PROPOSED SANITARY SEWER AND WATER OVERALL PLAN

EW STEM BUILL
1601 39th AVE SE
Puyallup, WA 98374 PIERC

SITE PERMIT SET

C6.2

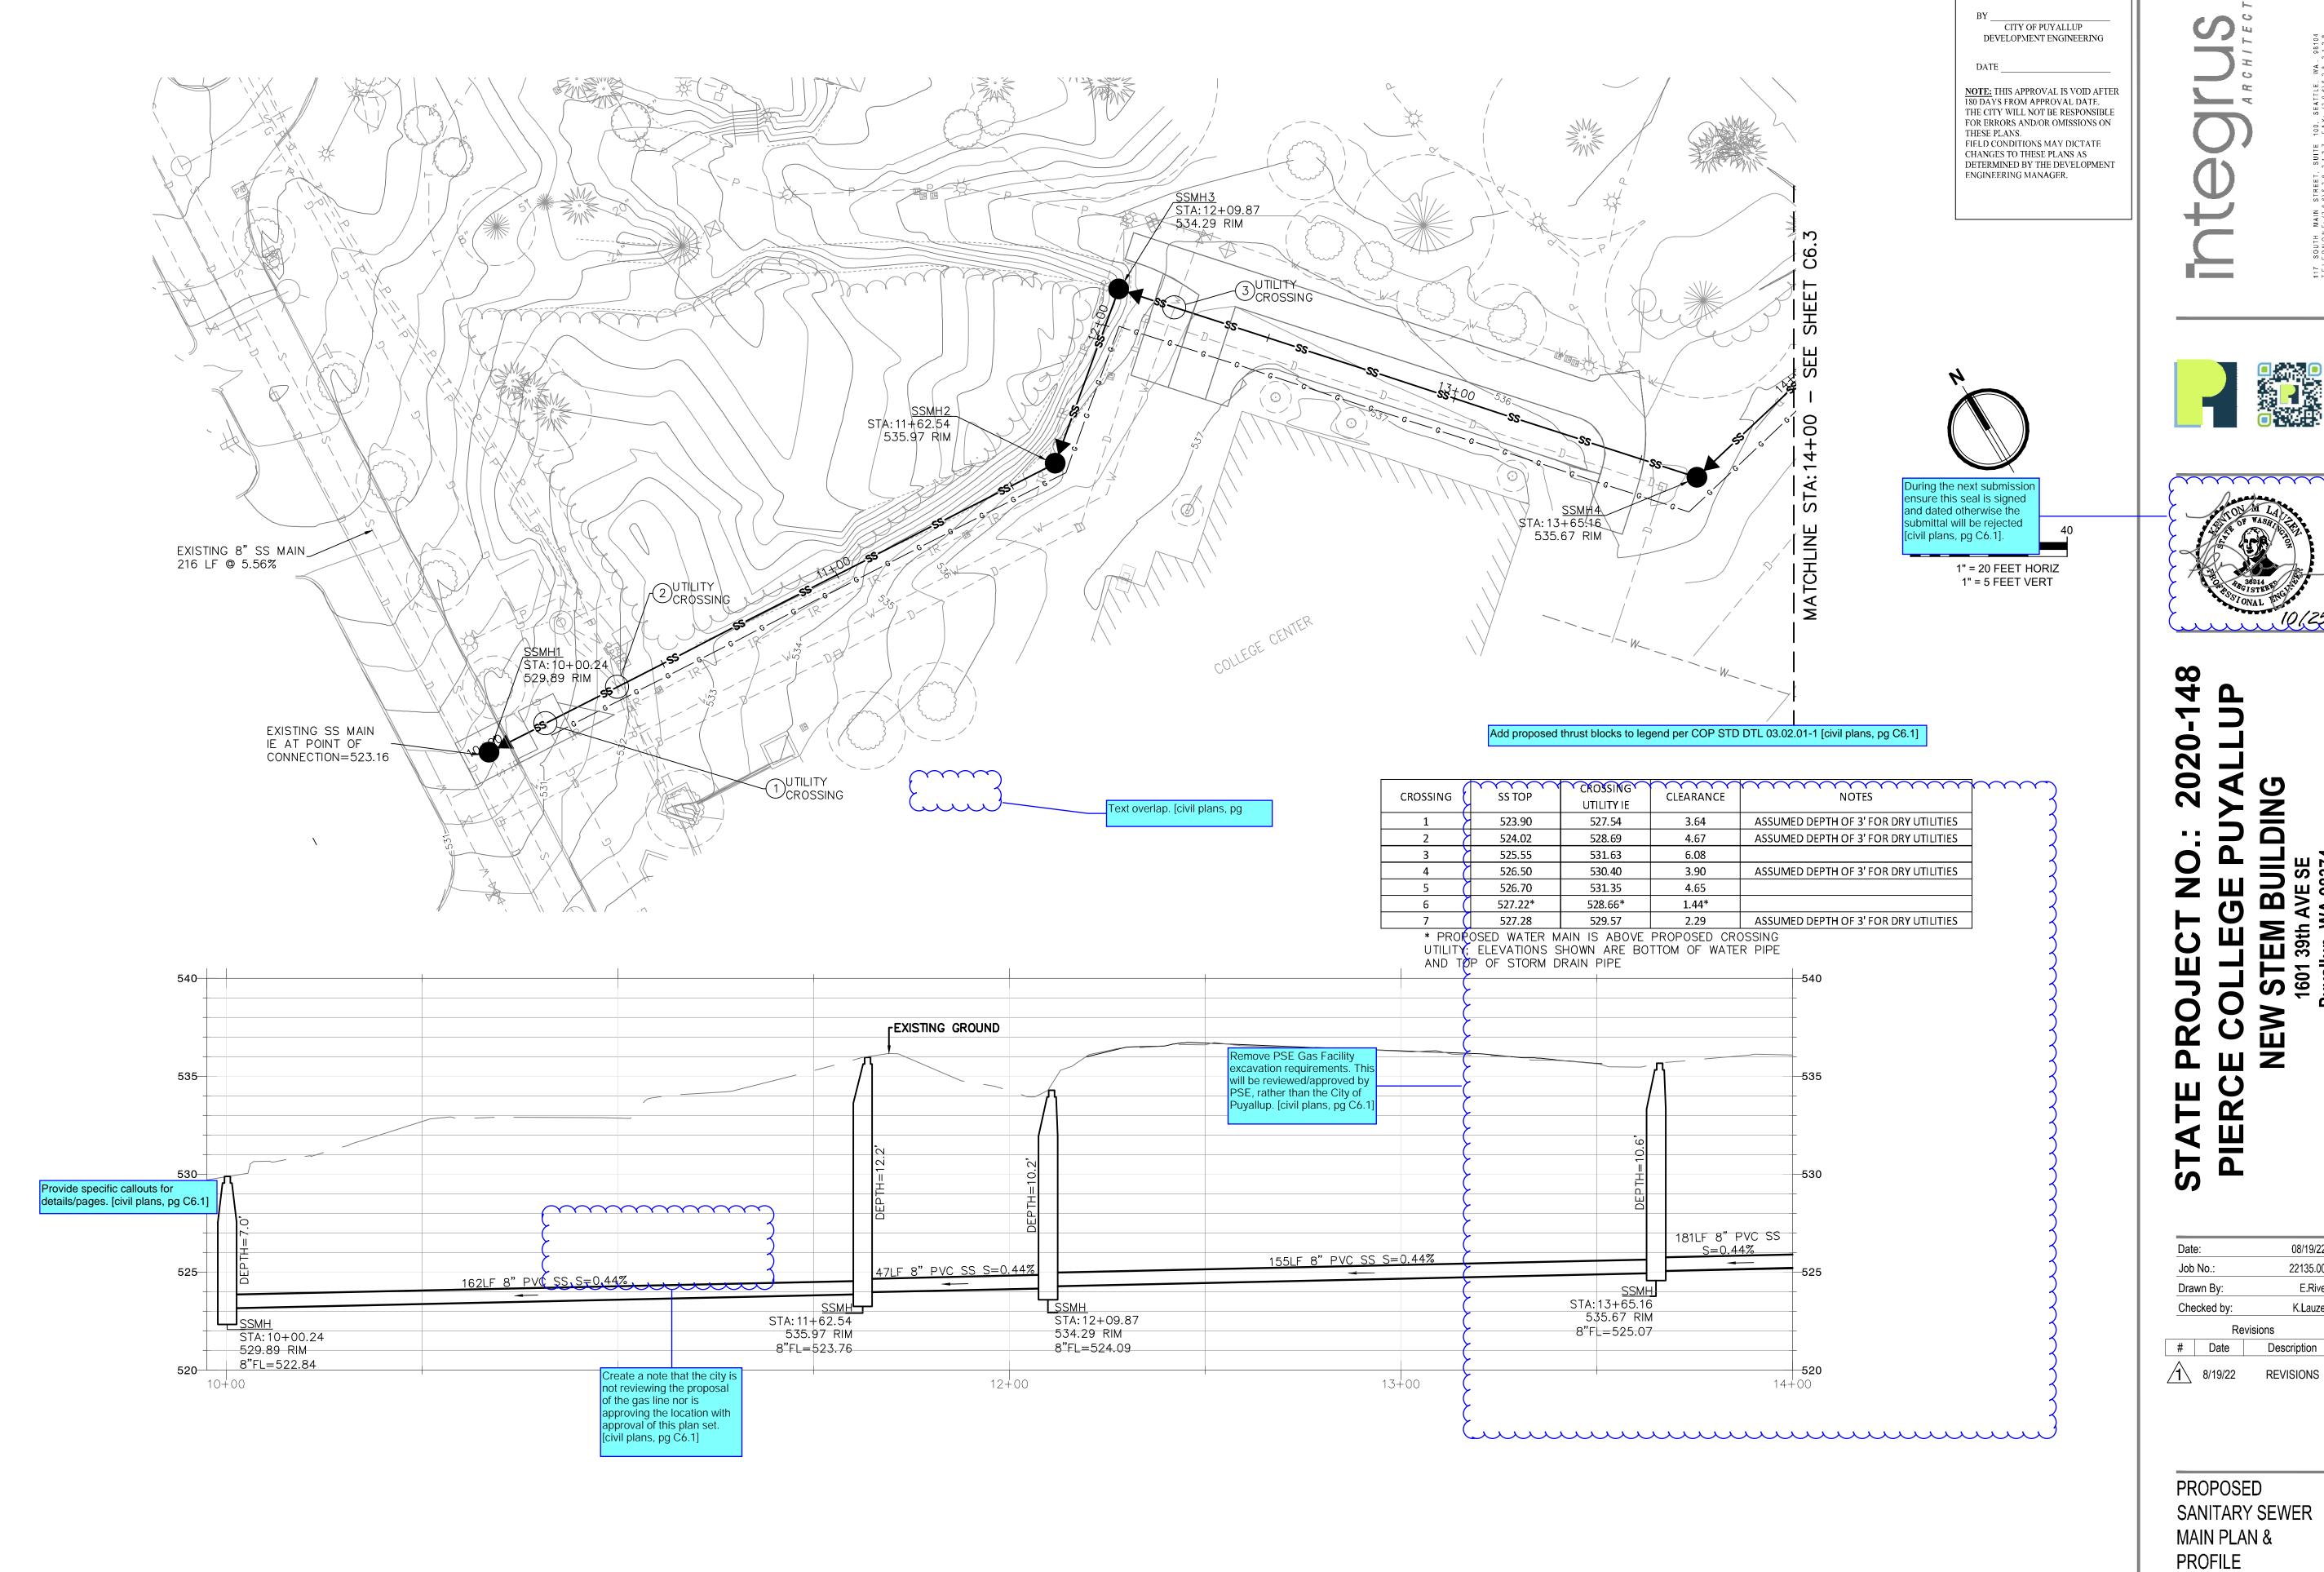
STA: 16+41.27 INSTALL SSCO PER COP STD DTL 04.03.05 ON SHEET C6.7 STA:16+43.27 CONNECT TO BUILDING SEWER STUB AT IE 527.91 FIRE HYDRANT TO BE INSTALLED PER COP STD DTL 03.05.01 ON SHEET C6.3 UTILITY CROSSING STA: 15+45.93 533.50 RIM . 1 Provide pipe crossing information. [civil plans, pg C6.2]

label the sewer manhole number on the profile view. [civil plans, pg C6.2]

C6.4

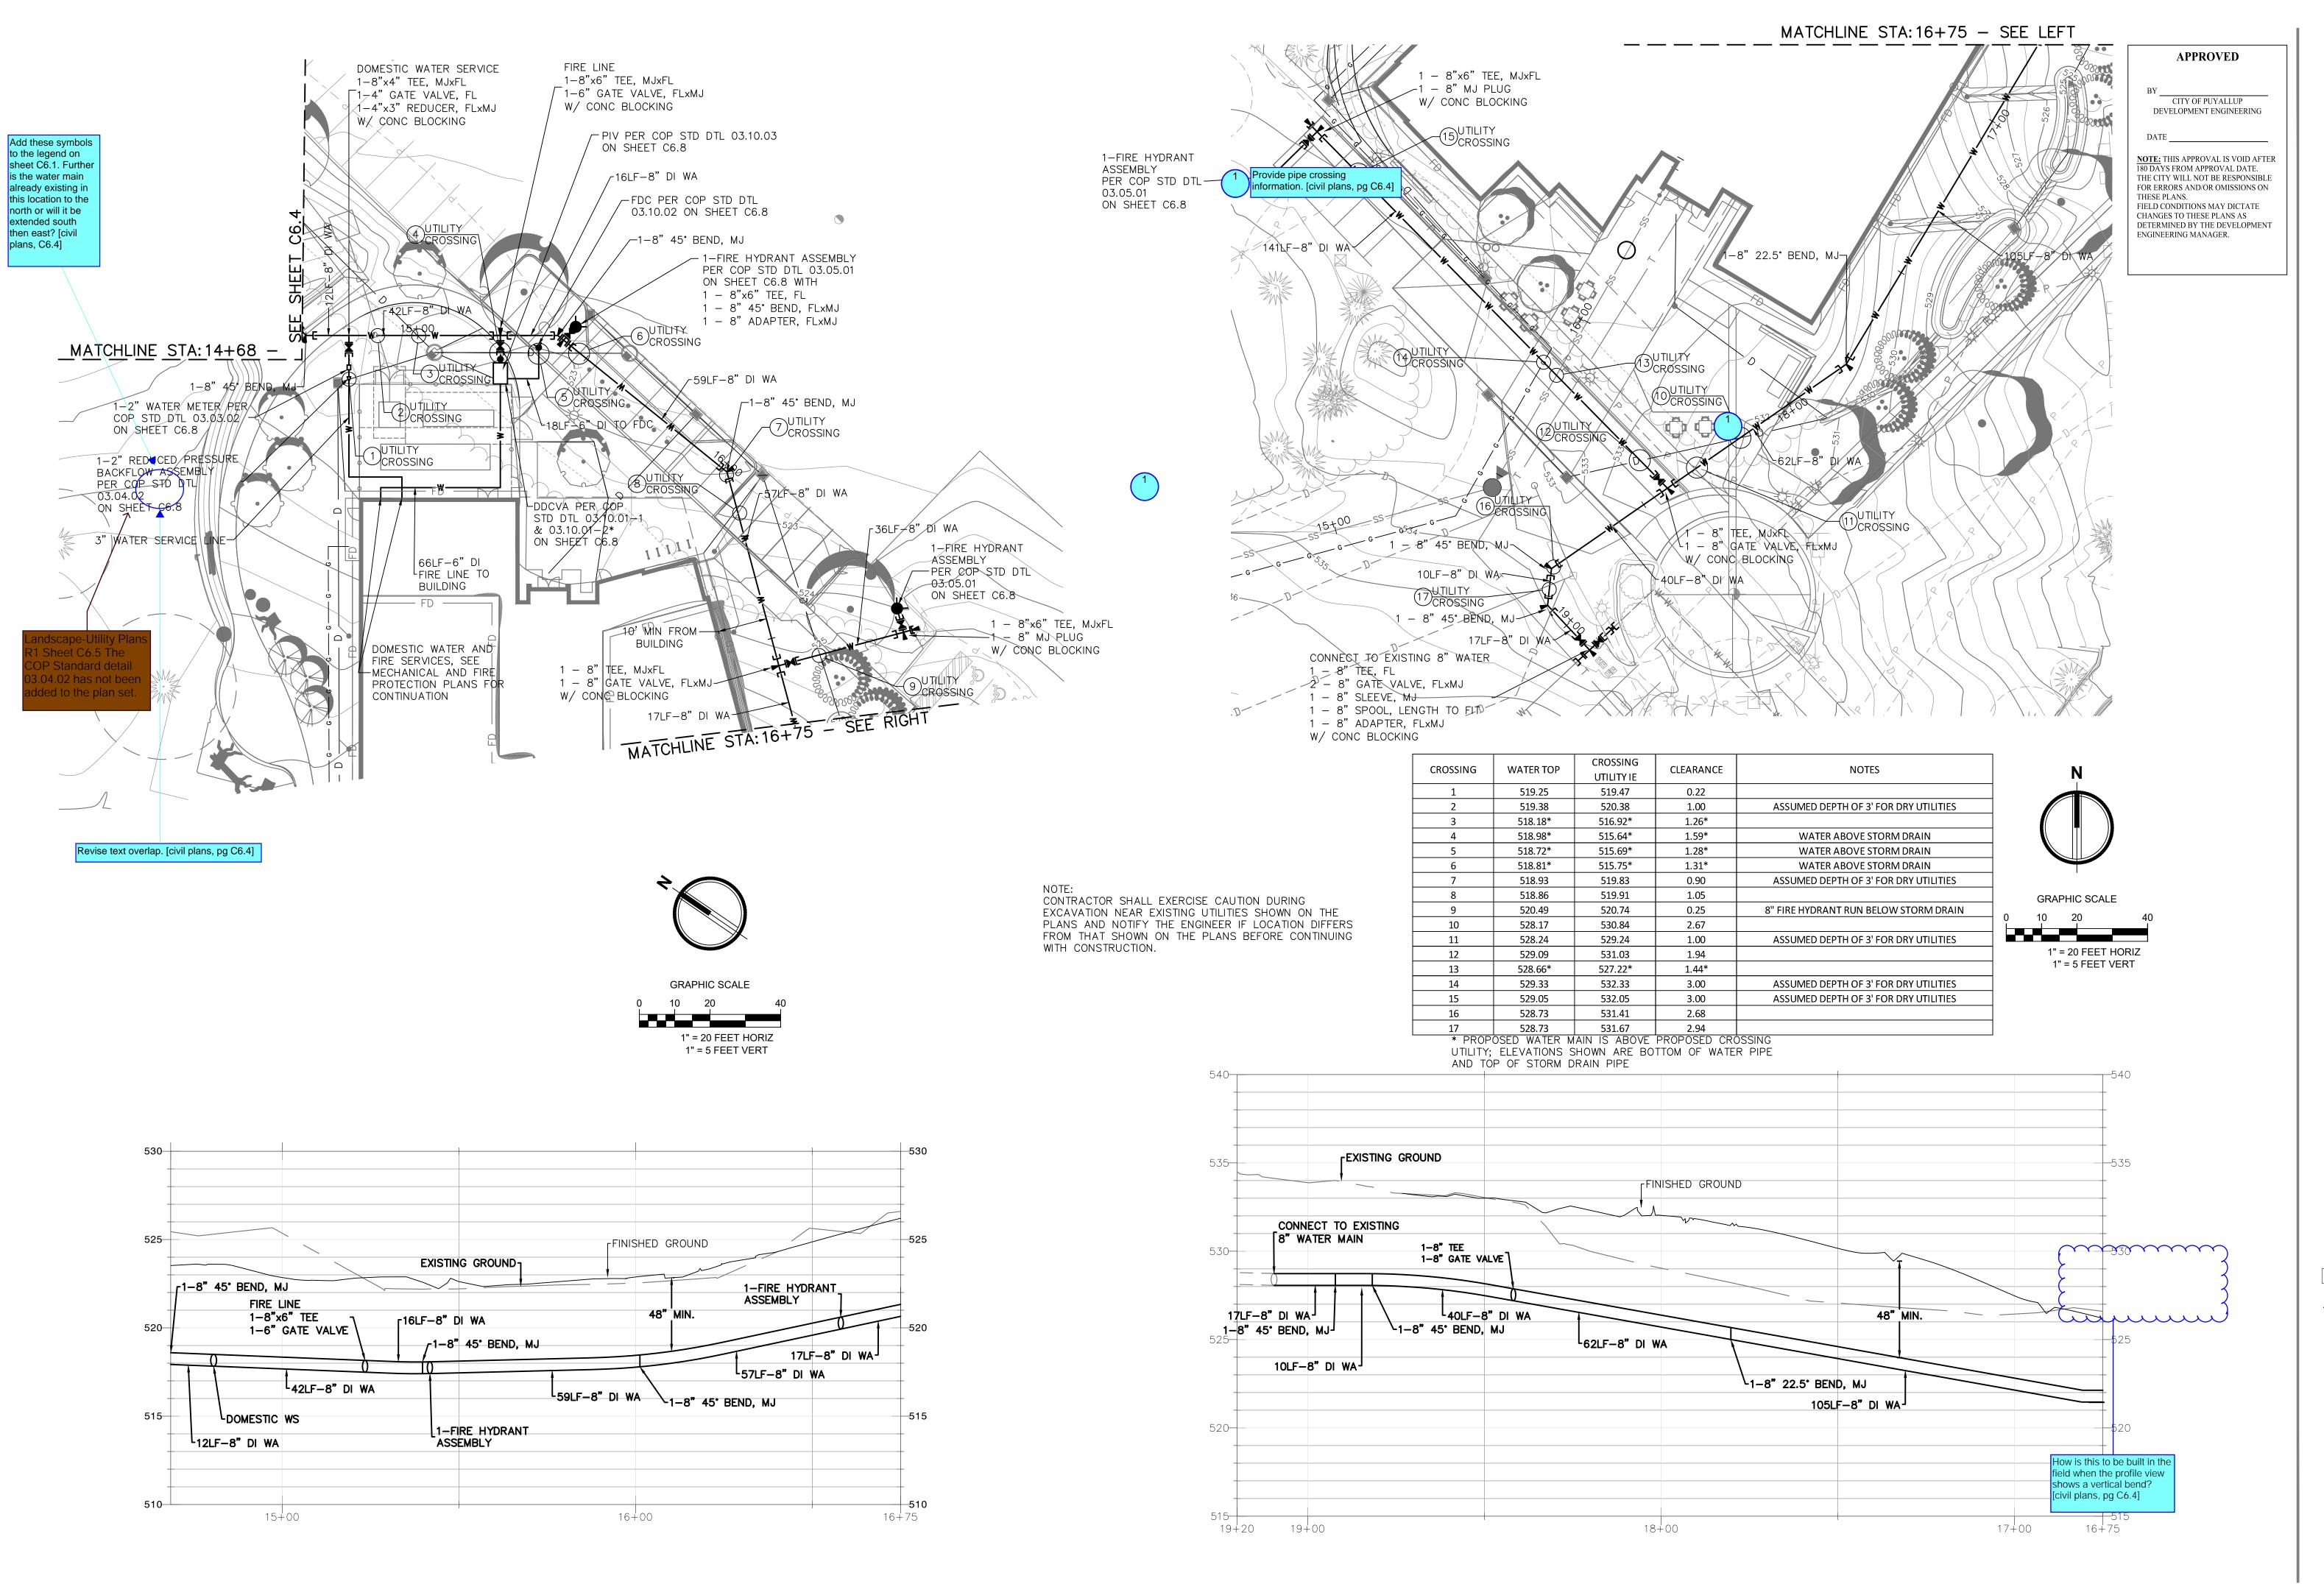
information. [civil plans, pg C6.4]

PROPOSED
SANITARY SEWER 8
WATER NOTES

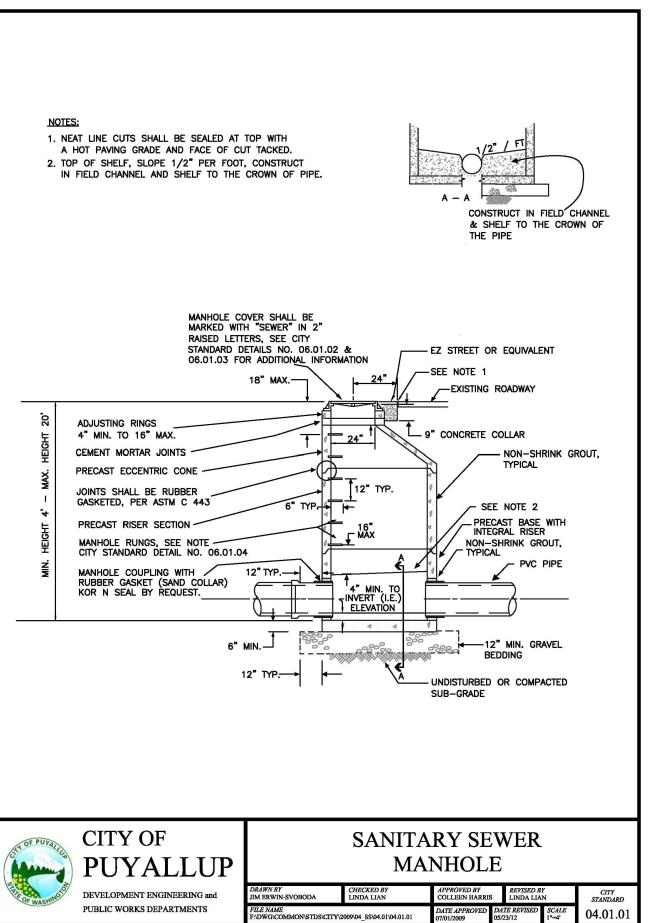
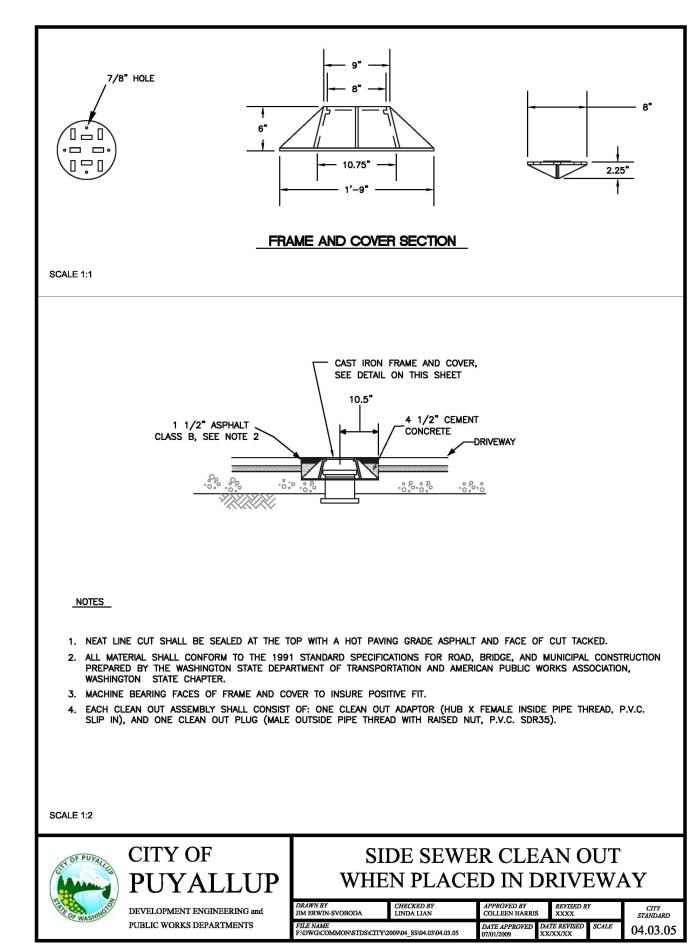
4. A COPY The domestic water service tee and gate valve is
5. ANY RE 4 inches whereas the water service line is called the proof of the control of the contr

IMPLEMENTAT out as 3 inches. [civil plans, pg C6.5]

9. SIDE Sand length of pipes. [civil LED IN ACCORDANCE WITH CITY STANDARD NOS. 04.03.01, 04.03.02, 04.03.03 AND 04.03.04. SIDE SEWER INSTALLATION WORK SHAIL PIPER SEWER INSTALLATION INDUSTRIAL SAFETY AND HEALTH ACT (WISHA).

10. ALL SEWER PIPE SHALL BE PVC, POLYPROPYLENE, OR DUCTILE IRON. PVC SEWER PIPE SHALL CONFORM TO ASTM D-3034, SDR35 FOR PIPE SIZES 15-INCH AND SMALLER AND ASTM F679 FOR PIPE SIZES 18- TO 27-INCH, DUCTILE IRON PIPE SHALL BE CLASS 51 OR GREATER, LINED WITH PROTECTO 401TM EPOXY LINING OR EQUIVALENT, UNL Show pipe crossing info. The World Show pipe cross pipe cross pi
